# Service-Information

Group 31 Front Fork	August 1983	Bulletin No.: 31 009 83 (2082)
------------------------	----------------	-----------------------------------

RE: FRONT FORK NOISE

Valve Disk Washer Part No. 31 42 1 242 645  
 Valve Housing Part No. 31 42 2 301 885  
 Spring Part No. 31 42 1 241 665  
 Ring Part No. 31 42 2 301 886  
 Retaining Ring Part No. 07 11 9 934 645

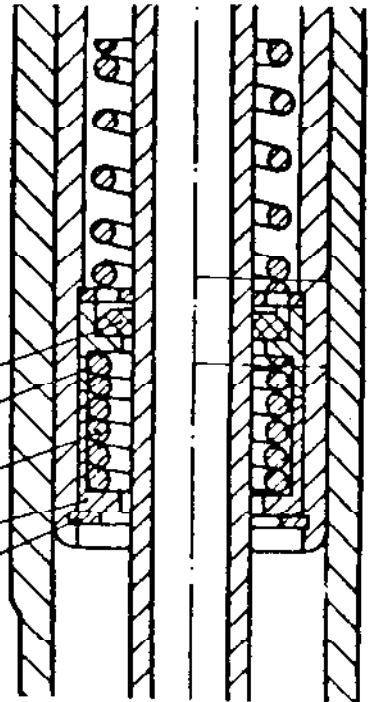
The telescopic front fork dampers on all models except R65 and R65LS now come equipped with a new spring-loaded valve housing, which eliminates axial play that may cause front fork noises.

It is no longer necessary to use shims for spacing as advised in Service Information 31 007 82 (2046). The valve washer is now provided with a chamfer that serves to cut down the noise level even further.

Note that this chamfer is always installed towards the perforated disk. Whenever repairs are performed, make sure both fork dampers are equipped with this new spring-loaded valve housing.

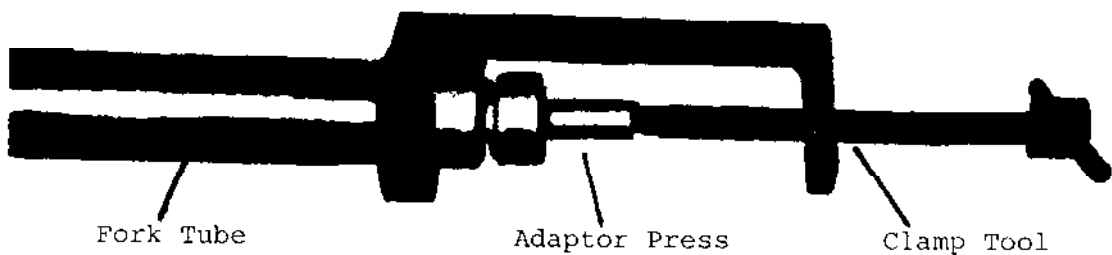
To install the two-part damper housing, use special tools No. 88 88 6 314 690 (clamp) and 88 88 6 314 693 (adaptor press). Fix the clamp and adaptor press as shown in the drawing below.

Using these tools, you will be able to compress the valve housing spring so it will be easy to install the retaining ring.
